## Product Change Notification / SYST-21MVID450

ERRATA - dsPIC33EVXXXGM00X/10X Family Silicon Errata and Data Sheet Clarification Document Revision

- 1) Updates silicon issues 6 (Input Capture) and 25 (Comparator).
- 2) Adds data sheet clarifications 2 (Interrupt Controller), 3 (Oscillator Configuration), 4 (Charge Time Measurement Unit (CTMU)) and 5 (Packaging Information).

## dsPIC33EVXXXGM00X/10X Family Silicon Errata and Data Sheet Clarification

FIGURE 1:

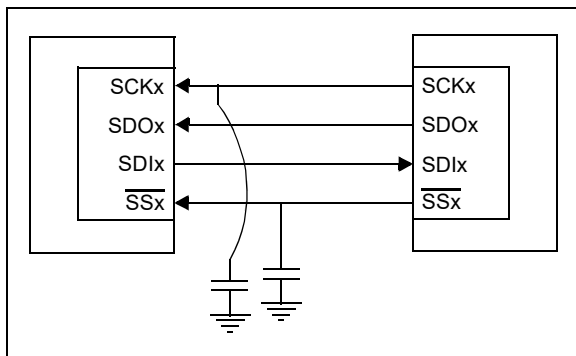
When the SPIx module is configured in SPIx Slave mode (MSTEN bit (SPIxCON1[5]) = 0), the frame slave (FRMEN bit (SPIxCON2[15]) = 1) and the SPIFSD bit (SPIxCON2[14] = 1), in Standard Buffer mode with the Clock Polarity Select bit, CKP = 0, the data are not transmitted in both 8-bit and 16-bit mode, but the data are being received correctly.

Adding a capacitance on the signal, as shown in Figure 1, will help the data to be received properly.

**FIGURE 2: TIMING DIAGRAMS FOR CENTER-ALIGNED AND EDGE-ALIGNED MODES**

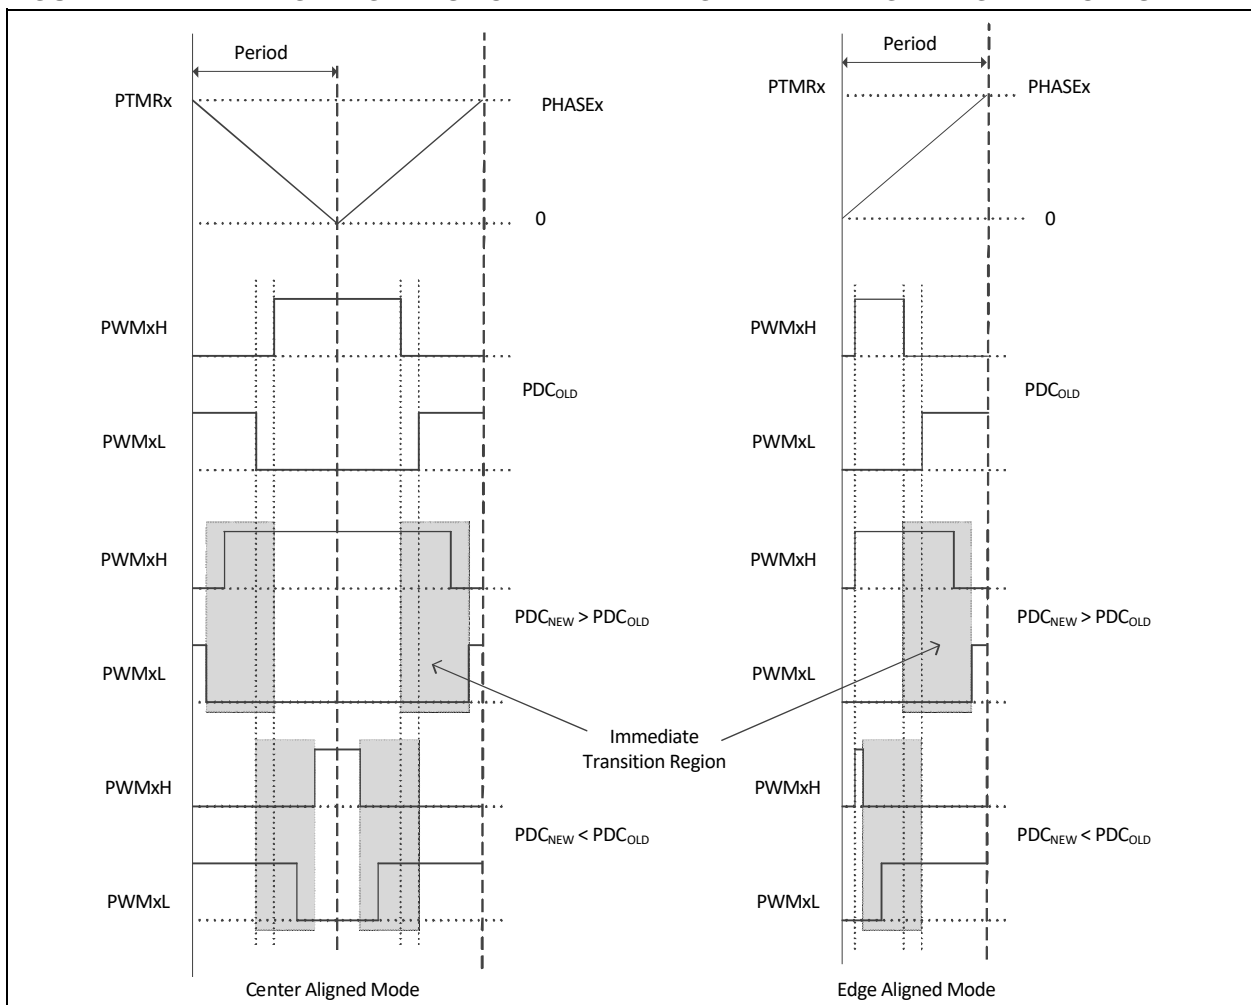
The PWM generator may not assert dead time on the edges of transitions. This has been observed when all of the following conditions are present:

In [Figure 2](#), if the duty cycle write occurred in the shaded box, then PWMxH and PWMxL will make an immediate transition without dead time.

However, in most applications, the duty cycle update timing can be controlled using the TRIGx trigger or Special Event Trigger, such that the above mentioned conditions are avoided altogether.

**FIGURE 3: ILLUSTRATION OF 1 T<sub>osc</sub> GLITCH WHEN PWM OVERRIDE IS TURNED OFF**

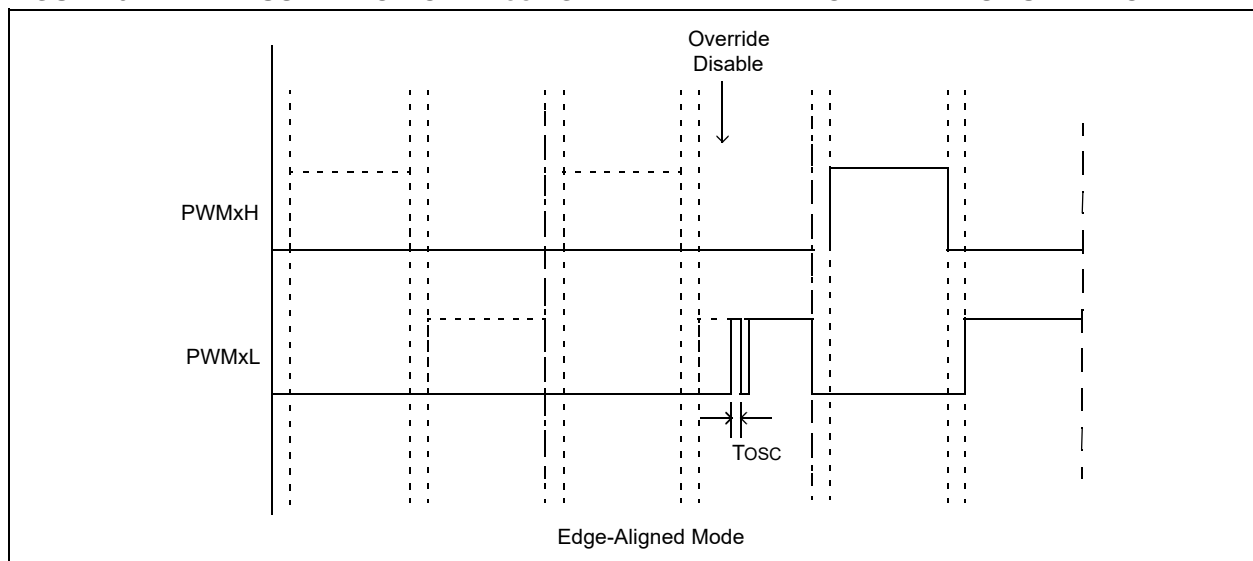
In Complementary mode after the PWM module is enabled (PTEN = 1), if the PWM override is turned off, a one T<sub>osc</sub> glitch will be present on the rising edge of either the PWMxH or PWMxL pins, whichever occurs first, as shown in Figure 3.

The glitch will be present on PWMxH/PWMxL every time the override state is changed from override enabled to override disabled. The width of this glitch is equal to one T<sub>osc</sub> when PCLKDIV[2:0] (PTCON2[2:0]) = 000. Increasing the PWMx input clock prescaler setting will increase the width of the glitch accordingly.

FIGURE 4:

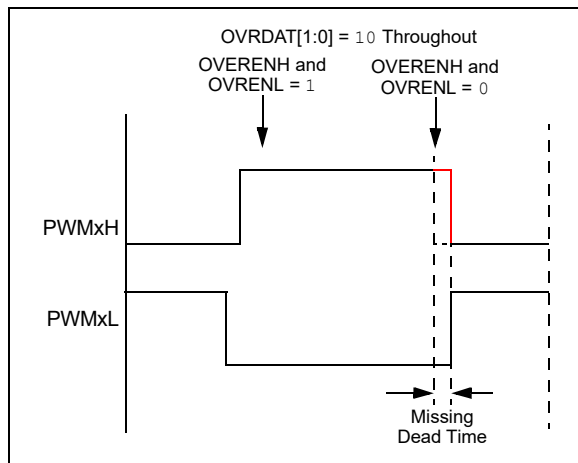
In Complementary Output mode, the expected dead time between transitions of the PWMxH and PWMxL outputs may not be asserted when the following occurs:

- Output override synchronization is configured to occur on the CPU clock boundary (IOCONx[0] = 0);
- Both PWMxH and PWMxL overrides are enabled prior to the event (OVRENH and OVRENL are both '1'), and
- Both overrides are disabled (OVRENH and OVRENL are both '0') at the instant the dead time should be asserted (Figure 4). This has been observed in both Center-Aligned and Edge-Aligned modes.

FIGURE 5:

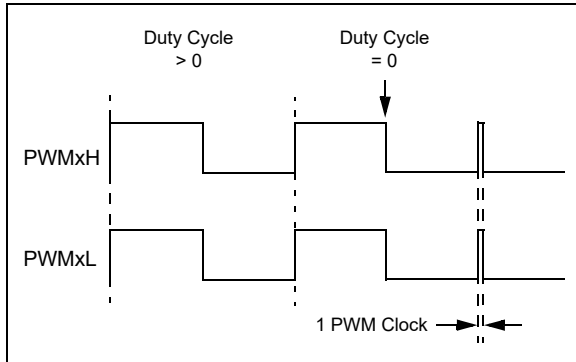
In the Redundant Output mode (IOCONx[11:10] = 10) and Push-Pull Output mode (IOCONx[11:10] = 01) with Immediate Update disabled (PWMCONx[0] = 0), when the Duty Cycle register is updated from a non-zero value to zero, a glitch pulse of a width equal to one PWM clock will appear at the next PWM period boundary, as shown in Figure 5, for the Redundant Output mode. Here, the Duty Cycle register refers to the PDCx register if PWMCONx[8] = 0 or the MDC register if PWMCONx[8] = 1.

If the application requires a zero duty cycle output, there are two possible work around methods:

1. Use the PWM override feature to override the PWM output to a low state instead of writing to the Duty Cycle register. In order to switch back to a non-zero duty cycle output, turn off the PWM override. The override-on and override-off events must be timed close to the PWM period boundary if the IOCONx register has been configured with IOCON[0] = 0 (i.e., output overrides via the OVDDAT[1:0] bits occur on the next CPU clock boundary).

2. Enable the Immediate Update (PWMCONx[0] = 1) while configuring the PWM module, i.e., before enabling the PWM module (PTCON[15] = 1). With Immediate Update enabled, writes to the Duty Cycle register can have an immediate effect on the PWM output. Hence, duty cycle write operations must be timed close to the PWM period boundary in order to avoid distortions in the PWM output.

**FIGURE 6:**

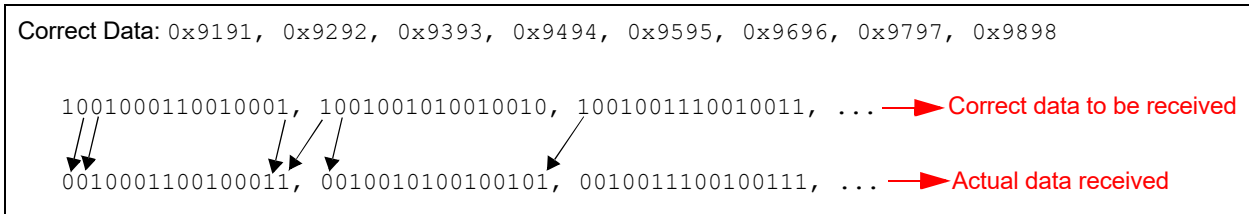
Received data of the SPI are sampled one clock cycle late for the following conditions:

For example, the correct data that should be received are 0x9191, 0x9292, 0x9393, 0x9494, 0x9595, 0x9696, 0x9797, 0x9898, but the actual data received are 0x2323, 0x2525, 0x2727, 0x2929, 0x2B2B, 0x2D2D, 0x2F2F, 0x3130 (Figure 6).

**FIGURE 7: SIMPLIFIED BEHAVIOR**

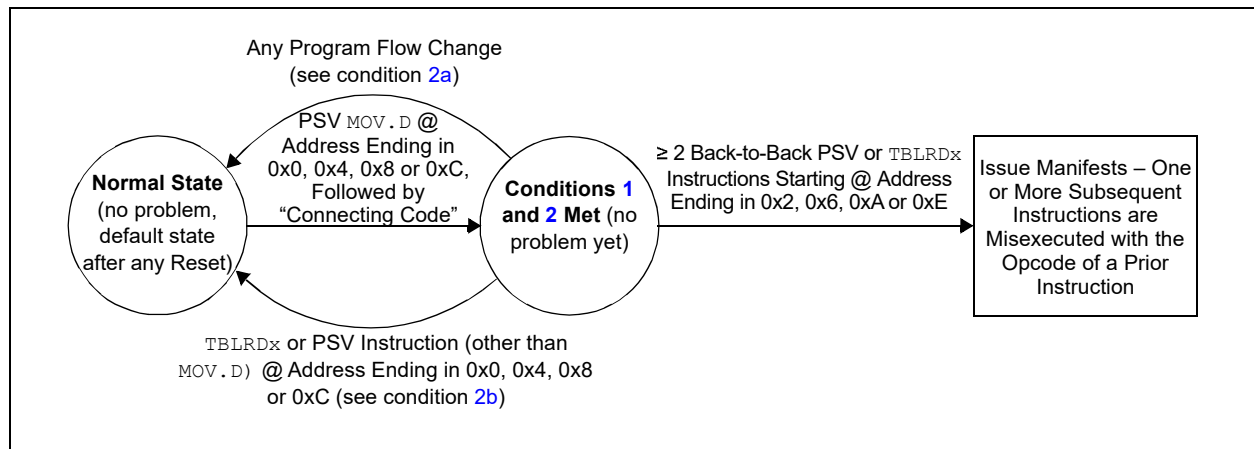
3. $\geq 2$ back-to-back PSV or <code>TBLRDx</code> instructions are executed (following the code of condition 2), where the first of the back-to-back instructions is located at an address ending in 0x2, 0x6, 0xA or 0xE.

[Figure 7](#) provides an example of the effective behavior.

1. All instances of PSV MOV.D can be replaced with two PSV MOV instructions instead. Non-PSV MOV.D instructions acting on RAM/SFRs do not need to be modified; or
2. If not already present, a program flow change instruction (such as BRA \$+2) can be inserted above back-to-back data Flash read sequences; or
3. Back-to-back data Flash read instruction sequences can be broken up by inserting a non-Flash read instruction (such as a NOP), in between the Flash read instructions; or
4. The alignment of the code can be shifted to avoid the required opcode location addresses.

### 64-Lead Plastic Quad Flat, No Lead Package (MR) – 9x9x0.9 mm Body w/lt 5.40 x 5.40 Exposed Pad [QFN]

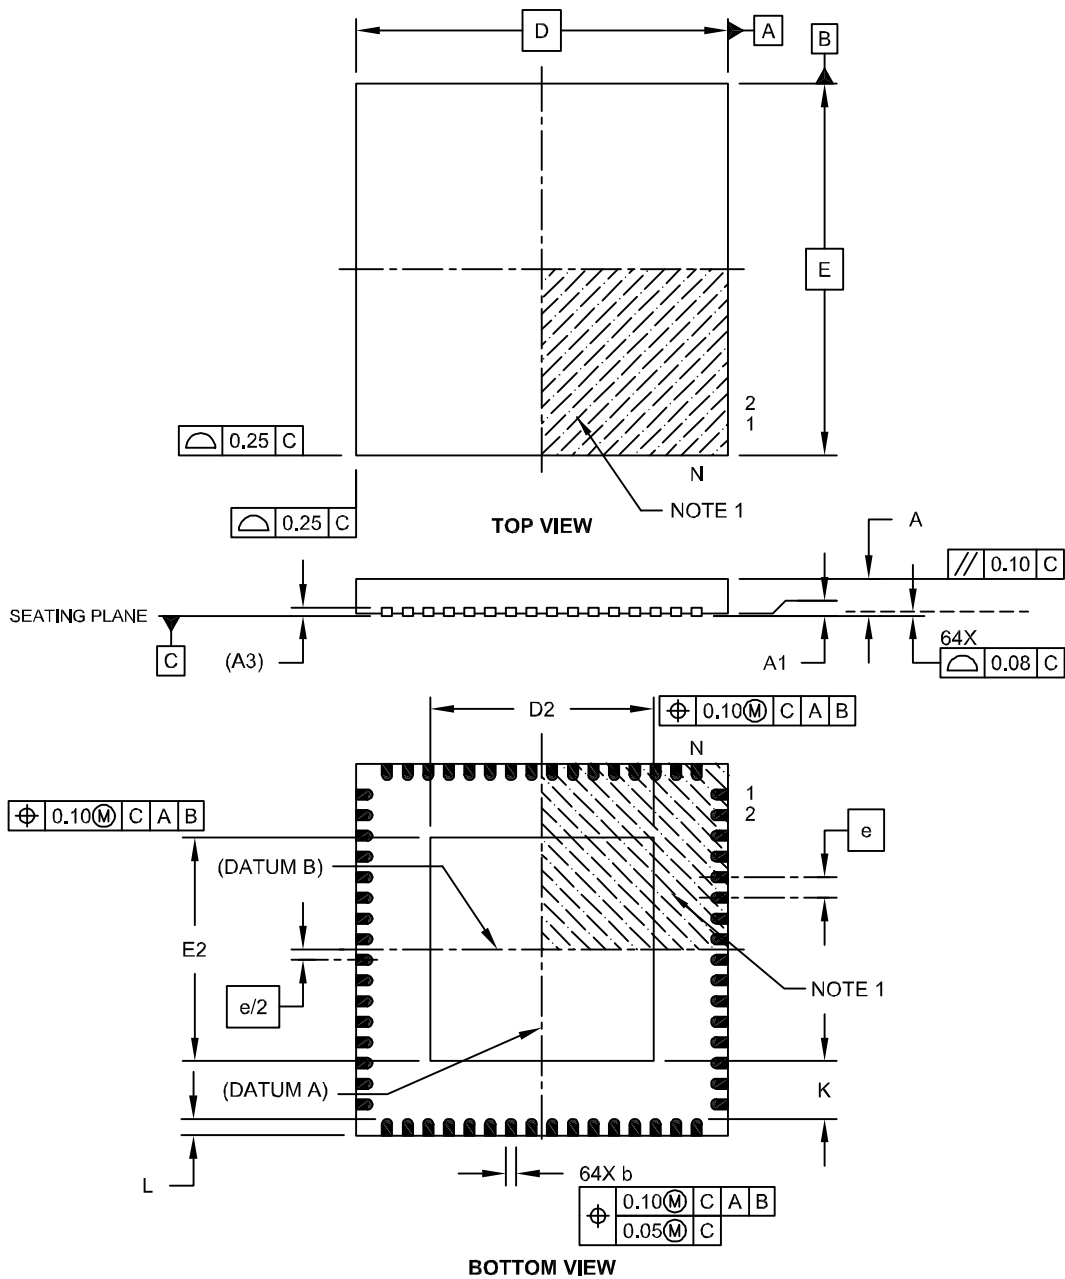
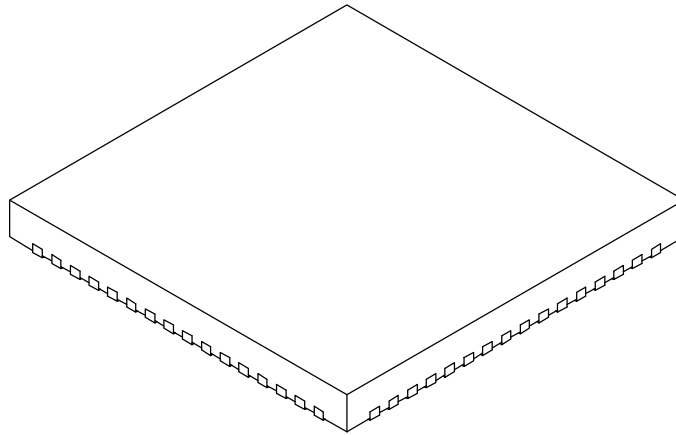
The package drawing for the 64-pin QFN device has been updated with the 64-Lead Plastic Quad Flat, No Lead package (MR) – 9x9x0.9 mm Body with 5.40x5.40 Exposed Pad [QFN] package drawing as shown below.
